South Humber Bank Energy Centre Project

The South Humber Bank Energy Centre Order

7.7 - Statement of Common Ground with Network Rail

Applicant: EP Waste Management Ltd
Date: January 2021

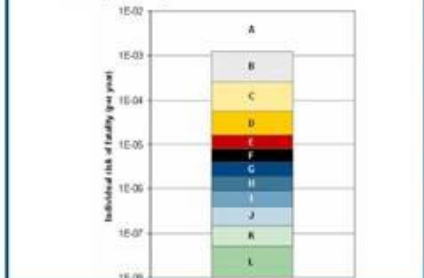
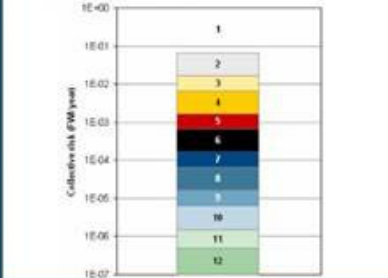
Date	Details
	<p data-bbox="510 337 1455 370"><i>from preferred to least preferable – Green, Double Yellow, Yellow, Red</i></p> <p data-bbox="510 386 1633 418"><i>Please find as follows an aid in deciphering the ALCRM scores and what they mean.</i></p> <div data-bbox="531 443 1260 922" style="border: 1px solid black; padding: 10px;"> <p data-bbox="562 459 636 492">Risk</p> <p data-bbox="562 524 1150 548">Collective Risk and Individual Risk are also presented as simplified rankings.</p> <div style="display: flex; justify-content: space-around;"> <div data-bbox="541 548 903 922" style="border: 1px solid black; padding: 5px;"> <p data-bbox="636 557 808 573">Individual Risk ranking</p> <ul style="list-style-type: none"> <li data-bbox="552 589 892 638">■ Allocates individual risk into rankings A to M (A is highest, L is lowest, and M is 'zero risk' for sleeping dog or crossing on mothballed line) <li data-bbox="552 646 892 678">■ Allows comparison of individual risk to average users across any crossings on the network.  </div> <div data-bbox="913 548 1260 922" style="border: 1px solid black; padding: 5px;"> <p data-bbox="1003 557 1171 573">Collective Risk ranking</p> <ul style="list-style-type: none"> <li data-bbox="919 589 1249 638">■ Allocates collective risk into rankings 1 to 13 (1 is highest, 12 is lowest, and 13 is 'zero risk' for sleeping dog or crossing on mothballed line.) <li data-bbox="919 646 1249 678">■ Can easily compare collective risk between any two crossings on the network.  </div> </div> </div> <p data-bbox="510 954 1890 1365"><i>Having discussed this increase with my operational risk experts, the type of mitigation would have to be barrier protection, which goes to fail safe should a barrier be damaged by vehicle incursion. I have been advised that the infrastructure for these is in the region of £290k per level crossing. This does not include required changes to signalling, communications, nor road infrastructure changes. Given the Marsh Lane has a 'substandard' width (<4m) with minimal passing places and bounded by third party land, I would feel this would push the costs for this route up significantly. The Kiln Lane level crossing fares a little better. The Western approach, whilst improved from the east, has its own difficulties. The route is via a large and busy industrial estate. From a brief desktop review, it appears that there are a high proportion of businesses that either service or would require deliveries by LGV/HGV. As you will imagine, this brings in a significant number of LGV/HGVs, and using this as your preferred route, will only exacerbate traffic volumes. Your traffic modelling also shows projected movements of 17 HGV's per hour in each direction, or one every 1¾ minutes. This significantly increases the chance of head on</i></p>

Date	Details
	<p><i>meets between vehicles and the potential for vehicles to 'back up' over the crossing. Your vehicle modelling states 'PCU' Passenger Car Units, however HGV are two to three times the length of PCUs, therefore I argue that your Max Queue output is skewed and does not accurately represent the scenario with HGVs.</i></p> <p><i>Given as noted in the first paragraph, please can you provide evidence that you have reviewed the route via the north and submit robust reasoning behind your evaluation and decision.</i></p> <p><i>Lastly, I notice that your report identifies a southern access via the A180, Westgate roundabout and Moody Lane, where no mitigation is proposed due to the 'small percentage that development flows are adding to the junction'. I would like to understand further why this could not be a preferred route. It appears to provide a suitable route that needs no upgrade to proposed figures, whilst not requiring the use of a level crossing and more of the access via A Class roads.</i></p> <p><i>I look forward to receiving your report and findings on the areas noted above."</i></p> <p>A report from the Applicant was submitted to Network Rail on 16 October 2020.</p>

16 October 2020	The Applicant submitted a technical response to Network Rail's objection (see copy in Appendix A).
6 November 2020	<p>Network Rail submitted an updated note of technical detail to the Applicant on 6 November 2020 and responded as follows:</p> <p><i>"Network Rail objects to the proposed routes to the location of the South Humber Bank Energy Centre. This is on the grounds of significant increase to traffic, specifically Heavy Goods Vehicles as noted in your documents 'Annex 23_ES VOL III Appendix 9A - Traffic Volumes over Kiln Lane LC' and 'EN010107-000241-SHBEC DCO - 6.4.12 ES Vol III Appendix 9A Transport Assessment File 1 - Main Document (1)'. This document provides technical information outlining why the proposed routes are unsafe, what is required to make the proposed routes safe and justifications as to costs.</i></p> <p><u>ALCRM modelled risk values for level crossings</u></p>
